Defect and Noncompliance Report Guide for Vehicle Manufacturers
PART 573 Defect and Noncompliance Report

Blue Bird Wanderlodge and BMC model coaches manufactured on or after March 01, 1993 and delivered through July 01, 1998.

The Aqua-Hot heating system installed on subject coaches contains insulation that, should it become saturated with fluid, could cause an electrical short which in turn become a fire hazard.

SUBJECT: Safety Recall Campaign #98E-011; Aqua-Hot Heating System
Insulation

Safety Recall "INSULATION" Removal Procedures

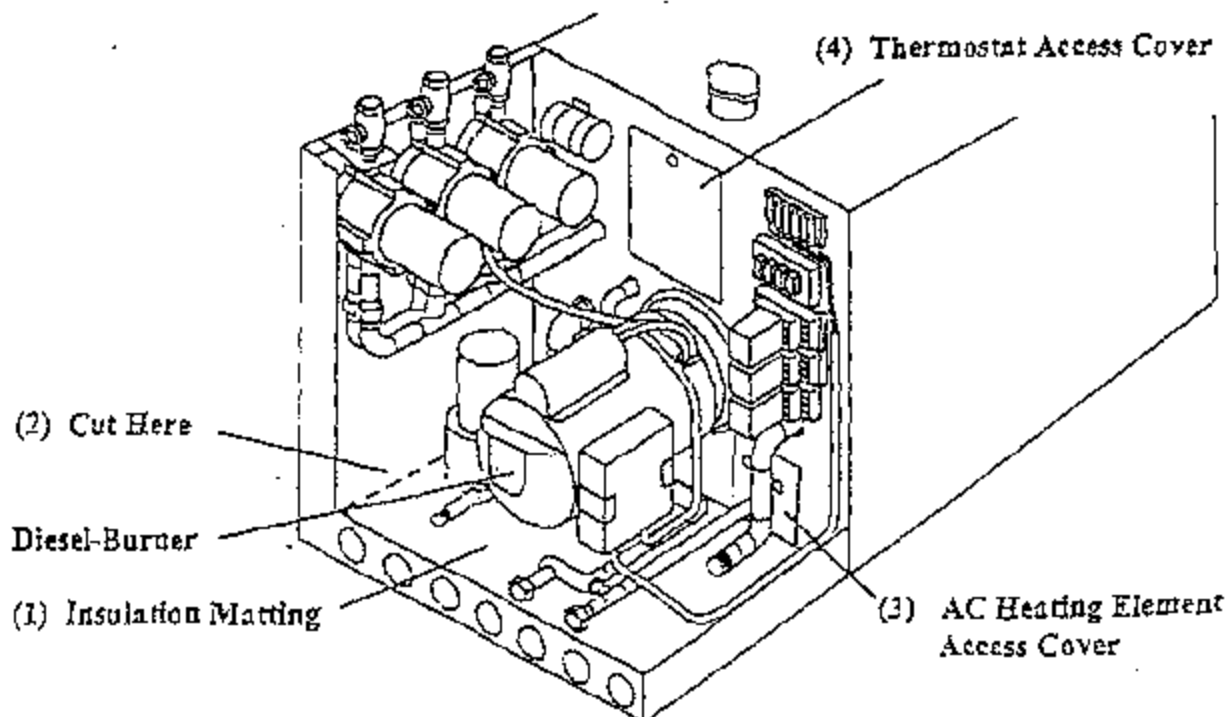
- A.) Turn the Aqua-Hot's Switch to the off position
- B.) Disconnect the 120 Volt AC power at the breaker panel.
- C.) Locate and remove the Aqua-Hot's main service access cover.
- D.) Locate the Insulation Matting (1) directly below the Diesel-Burner, see Illustration.
- E.) Utilizing a razor knife or equivalent, carefully cut the Insulation Matting (2) to separate the bottom from the back side and slide out from under the Diesel-Burner and discard.

- A.) Locate the AC Heating Element's Access Cover (3) and remove the two screws which hold the cover in place.

- * Re-check to make sure all power has been disconnected before removing this cover.
- B.) Remove the Access Cover, locate the Insulation Matting on the back side of the cover, and remove it by simply peeling it off.
 - C.) Re-install the Access Cover and the two mounting screws.

- A.) Locate the Thermostat's Access Cover (4) using the same methods as outlined in "Step 2" to remove the cover. Peel off the insulation matting and reinstall the cover and mounting screws.

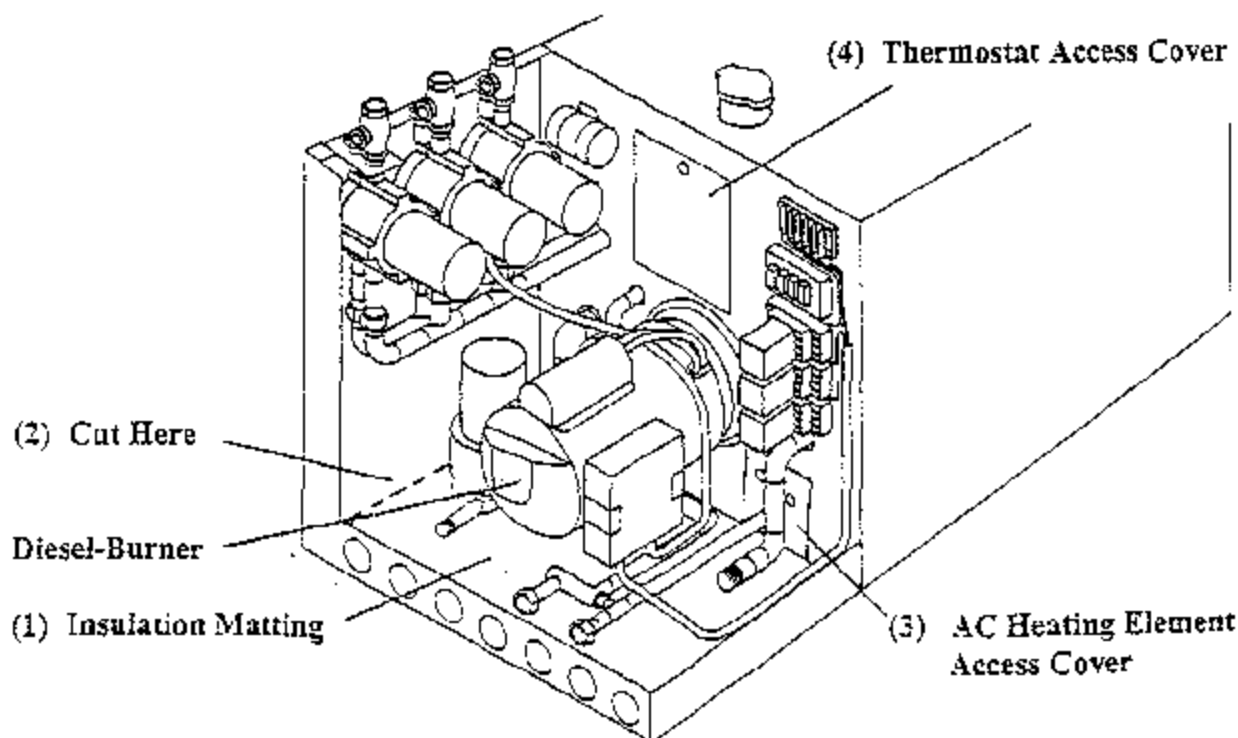
- A.) Turn the Aqua-Hot's Switch to the off position
- B.) Disconnect the 120 Volt AC power at the breaker panel.
- C.) Locate and remove the Aqua-Hot's main service access cover.
- D.) Locate the Insulation Matting (1) directly below the Diesel-Burner, see illustration.
- E.) Utilizing a razor knife or equivalent, carefully cut the Insulation Matting (2) to separate the bottom from the back side and slide out from under the Diesel-Burner and discard.

- A.) Locate the AC Heating Element's Access Cover (3) and remove the two screws which hold the cover in place.

- * Re-check to make sure all power has been disconnected before removing this cover.
- B.) Remove the Access Cover, locate the Insulation Matting on the back side of the cover, and remove it by simply peeling it off.
 - C.) Re-install the Access Cover and the two mounting screws.

- A.) Locate the Thermostat's Access Cover (4) using the same methods as outlined in "Step 2" to remove the cover. Peel off the insulation matting and reinstall the cover and mounting screws.

**SAFETY RECALL CAMPAIGN
AQUA-HOT HEATING SYSTEM MODIFICATION
BLUE BIRD NUMBER R98CB
NHTSA NUMBER 98E-011**

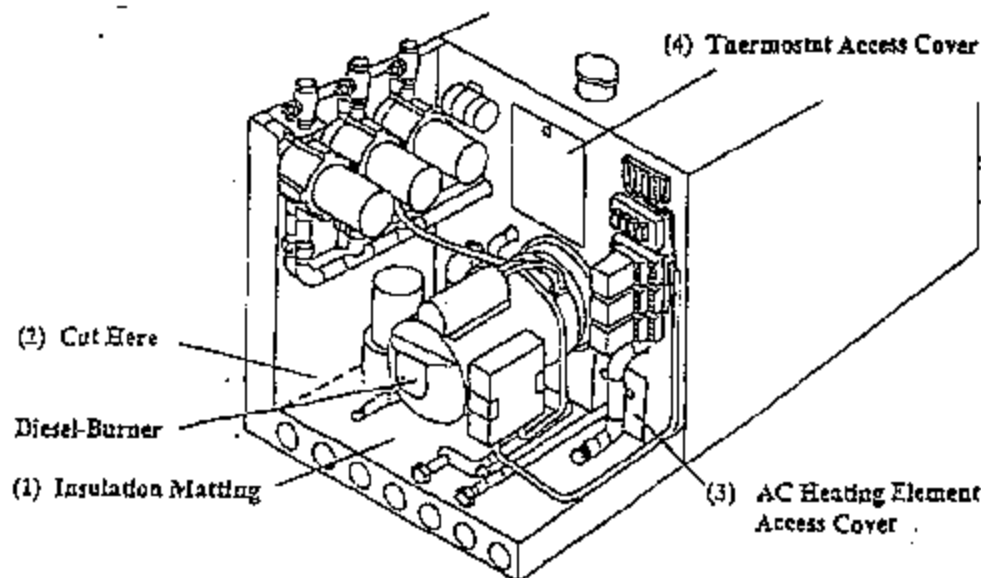
- A.) Turn the Aqua-Hot's Switch to the off position.
- B.) Disconnect the 120 Volt AC power at the breaker panel.
- C.) Locate and remove the Aqua-Hot's main service access cover.

- A.) Locate the AC Heating Element's Access Cover (3) and remove the two screws which hold the cover in place.

- Re-check to make sure all power has been disconnected before removing this cover.
- B.) Remove the Access Cover, locate the Insulation Matting on the back side of the cover, remove it by simply peeling it off.
- C.) Re-install the Access cover and the two mounting screws.

- A.) Locate the Thermostat's Access Cover (4) using the same methods outlined in "Step 2" to remove the cover. Peel off the insulation matting and reinstall the cover and mounting screws.

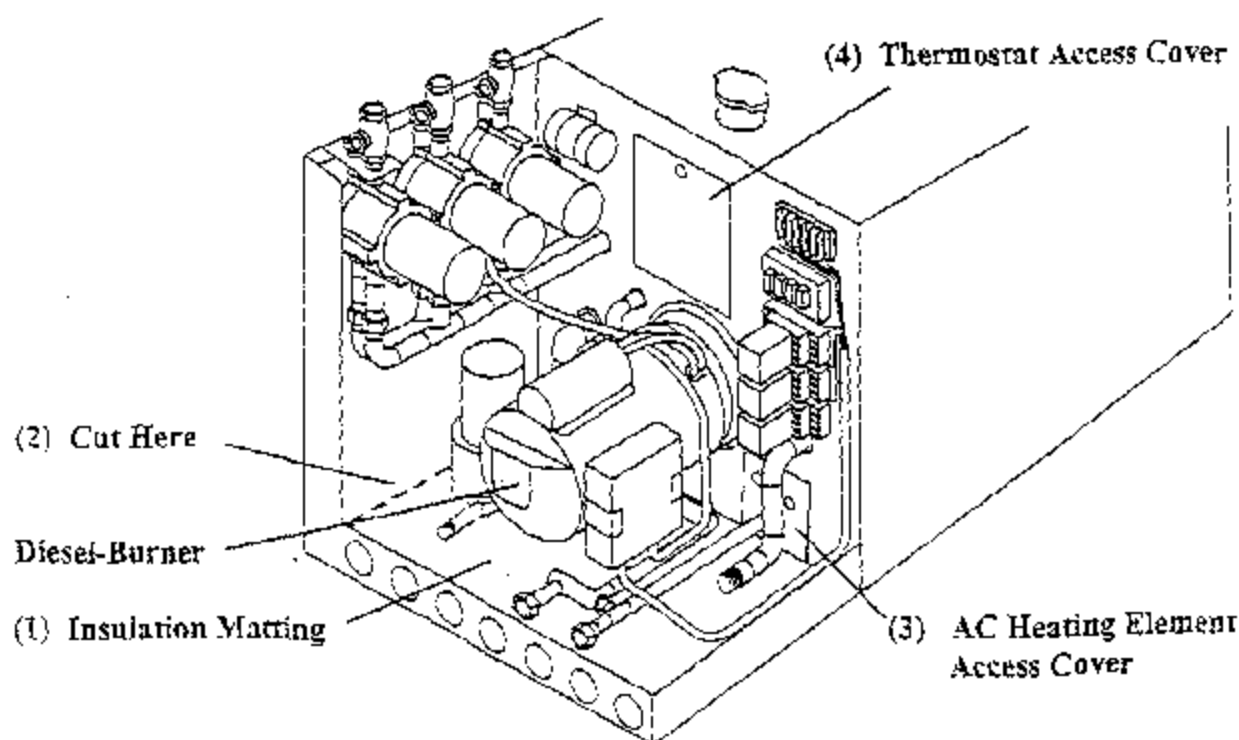
- A.) Turn the Aqua-Hot's Switch to the off position
- B.) Disconnect the 120 Volt AC power at the breaker panel.
- C.) Locate and remove the Aqua-Hot's main service access cover.
- D.) Locate the Insulation Matting (1) directly below the Diesel-Burner, see illustration.
- E.) Utilizing a razor knife or equivalent, carefully cut the Insulation Matting (2) to separate the bottom from the back side and slide out from under the Diesel-Burner and discard.

- A.) Locate the AC Heating Element's Access Cover (3) and remove the two screws which hold the cover in place.

- * Re-check to make sure all power has been disconnected before removing this cover.
- B.) Remove the Access Cover, locate the Insulation Matting on the back side of the cover, and remove it by simply peeling it off.
 - C.) Re-install the Access Cover and the two mounting screws.

- A.) Locate the Thermostat's Access Cover (4) using the same methods as outlined in "Step 2" to remove the cover. Peel off the insulation matting and reinstall the cover and mounting screws.

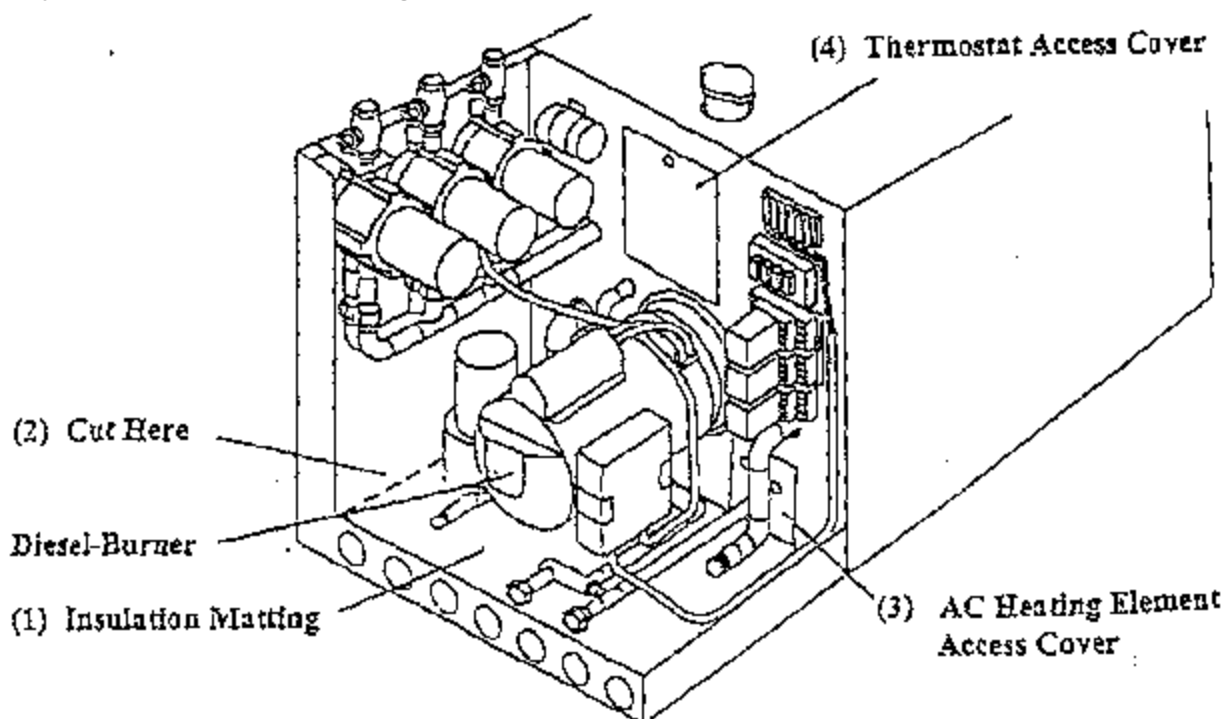
- A.) Turn the Aqua-Hot's Switch to the off position.
- B.) Disconnect the 120 Volt AC power at the breaker panel.
- C.) Locate and remove the Aqua-Hot's main service access cover.
- D.) Locate the Insulation Matting (1) directly below the Diesel-Burner, see illustration.
- E.) Utilizing a razor knife or equivalent, carefully cut the Insulation Matting (2) to separate the bottom from the back side and slide out from under the Diesel-Burner and discard.

- A.) Locate the AC Heating Element's Access Cover (3) and remove the two screws which hold the cover in place.

- * Re-check to make sure all power has been disconnected before removing this cover.
- B.) Remove the Access Cover, locate the Insulation Matting on the back side of the cover, and remove it by simply peeling it off.
- C.) Re-install the Access Cover and the two mounting screws.

- A.) Locate the Thermostat's Access Cover (4) using the same methods as outlined in "Step 2" to remove the cover. Peel off the insulation matting and reinstall the cover and mounting screws.
